Planning Commission Work Session Staff Report

May 22, 2013
Item 6.b.

- SUBJECT:** Work Session for PUD-96
- APPLICANT:** South Bay Development (Scott Trobbe)
- PROPERTY OWNER:** Pleasanton Gateway, L.L.C. (Scott Trobbe)
- PURPOSE:** Work Session to review and receive comments on an application for a Planned Unit Development (PUD) Development Plan to construct 210 apartment units, 97 single-family detached units, and related site improvements on an approximately 26.72-acre site.

Figure 7: Typical Lot Plan²⁵ for the Three-Story Single Homes.

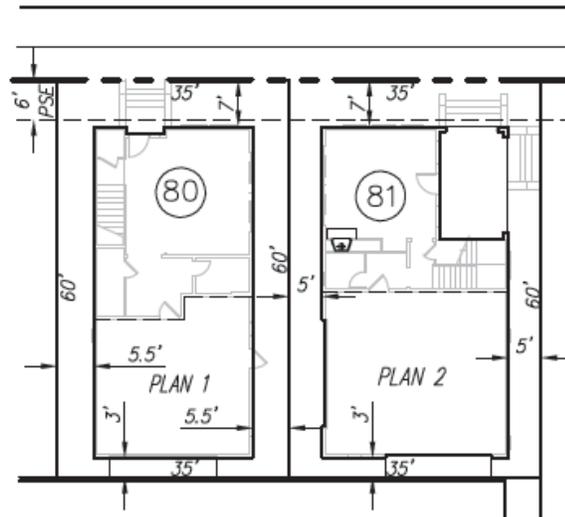
The Planning Commission has expressed its concerns on relatively large single-family detached homes on small lots.

The Walnut Hills development on the east side of Valley Avenue was developed with approximately 4,812-square-foot lots with single-family detached homes with a detached garage with/without a second-floor living area. The floor areas and floor area ratios for the four Walnut Hills models (with a second-floor living area over the detached garage) varied from: 1) 2,490 square feet (3,170 square feet); 2) 2,703 square feet (3,383 square feet); 3) 2,886 square feet (3,566 square feet); and, 4) 2,294 square feet (2,974 square feet), with the corresponding floor area ratios of: 1) 52 percent (66 percent); 2) 56 percent (70 percent); 3) 60 percent (74 percent); and, 4) 48 percent (62 percent).

6. Planning Commission Discussion:

Are the house sizes, lot sizes, and floor area ratios for the proposed single-family homes acceptable?

Figure 8: Typical Lot Plan²⁶ for the Two-Story Single-Family Homes.

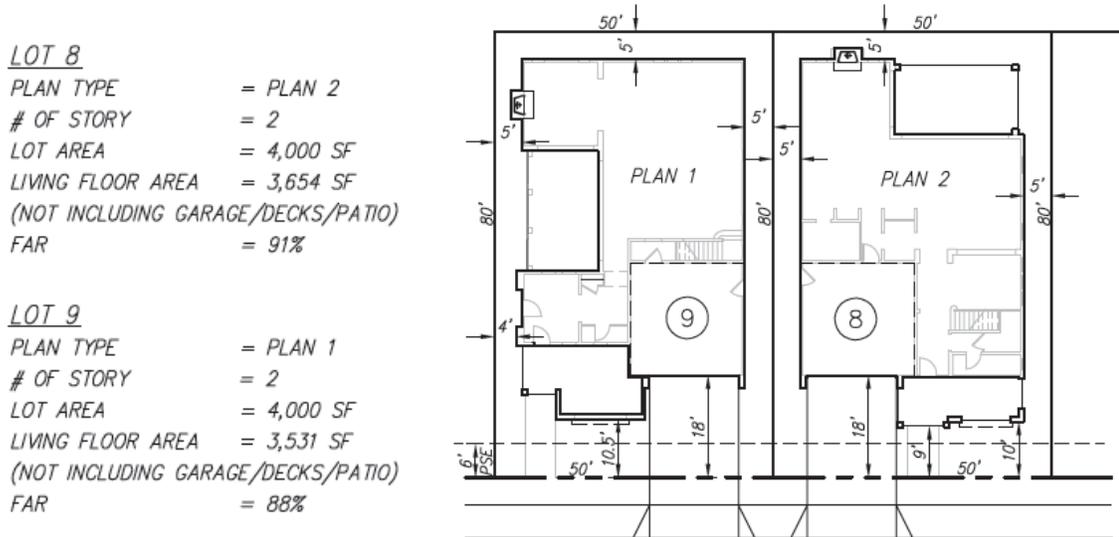
The two- and three-story tall single-family homes would provide a 10-foot wide side yard in lieu of a large rear yard. The applicant believes that the combination of the proposed side yards, private patio/balcony areas, the proposed common open areas, and the existing and planned facilities at the nearby Bernal Park off-set the provision of large rear yards for these buildings. The depth of the rear yards for the Walnut Hills development varied based by model, from 19 feet, 14 feet and 24 feet, 12 feet and 20 feet, and 17 feet and 27 feet between the house and the detached garage. Providing rear yards would require re-designing the proposed project resulting in a reduction in density for the two- and three-story single-family homes, or using a different unit with a smaller floor area for these areas of the project.

Figure 9: Proposed Pedestrian and Bicycle Circulation Plan²⁸

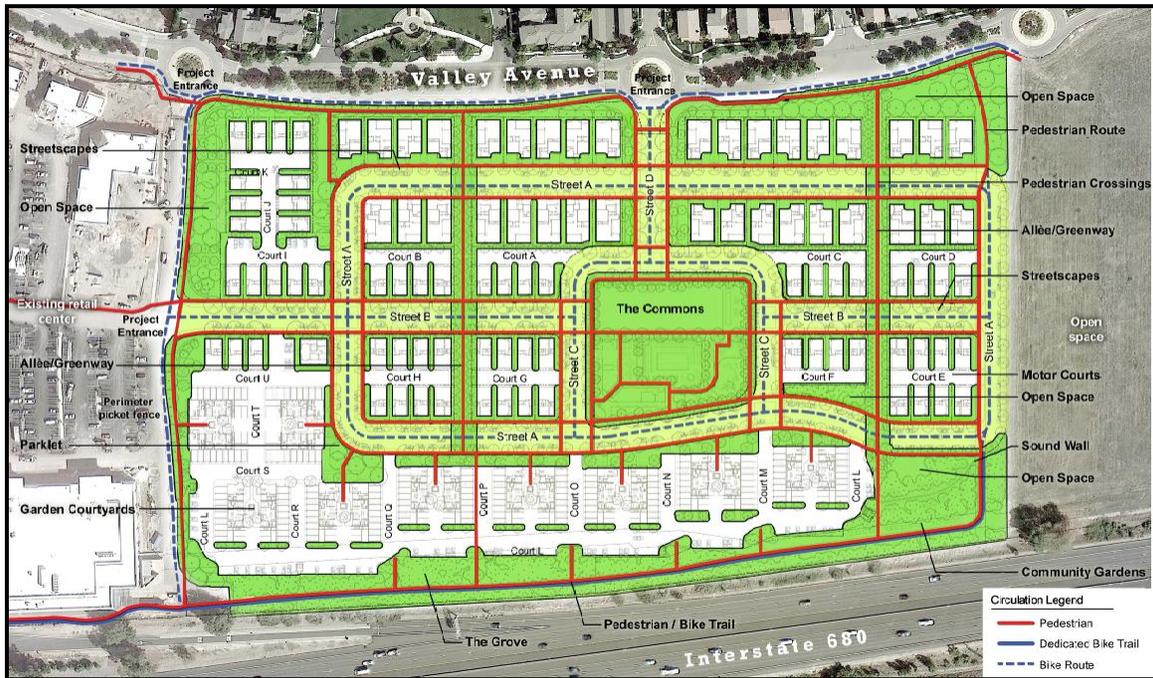
As shown on the plans, the internal sidewalk system is linked to the existing bus stop on Valley Avenue for the Livermore Amador Valley Transit Authority (LAVTA) Route 8A and 8B. Staff will continue to work with the applicant and LAVTA on moving the bus stop farther south on Valley Avenue to increase the separation between the bus stop and the proposed homes as well as moving the stop closer to the future park site.
